# UNITED STATES PATENT AND TRADEMARK OFFICE

# Office Action Summary

This is the first office action for application number 10/734,068, Modular Dental Chair Equipment Mounting System, filed on December 10, 2003.

3,550,892

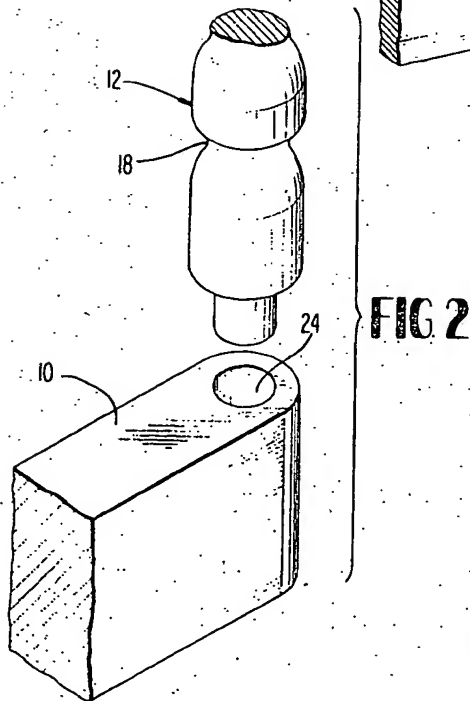
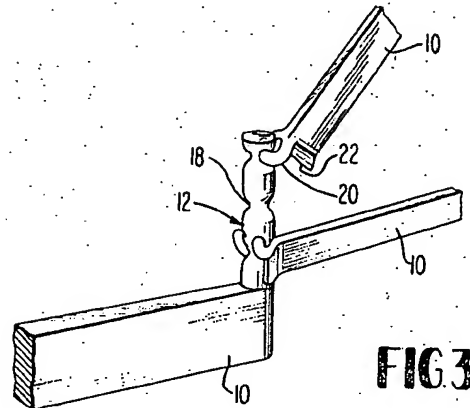
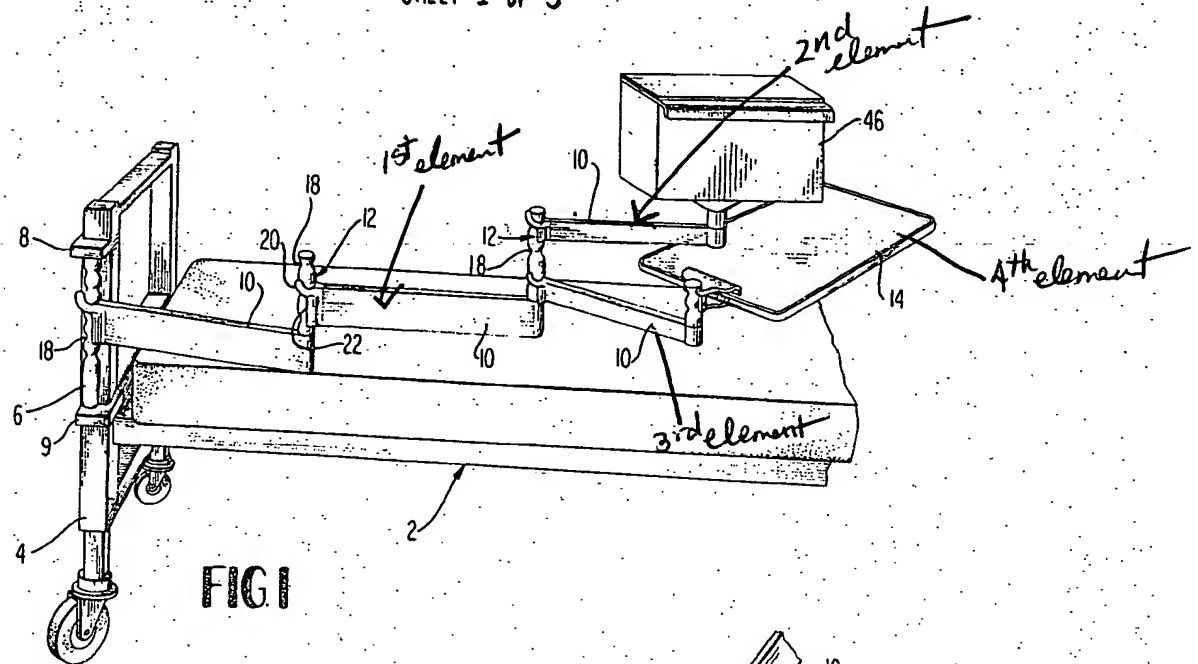
Claim 35 is rejected under 35 U.S.C. 102(b) as being anticipated by U.S. Patent 3,550,892 to Propst. Propst discloses an arm assembly comprising: a first element for pivotable attachment to a dental chair; a second element pivotably attached to an end of the first element a substantially vertical first pivot axis; a third element attached to the second element substantially along the first pivot axis; and a fourth element attached to the third element at a substantially vertical second pivot axis that is horizontally spaced from the first pivot axis. See Attachment for details.
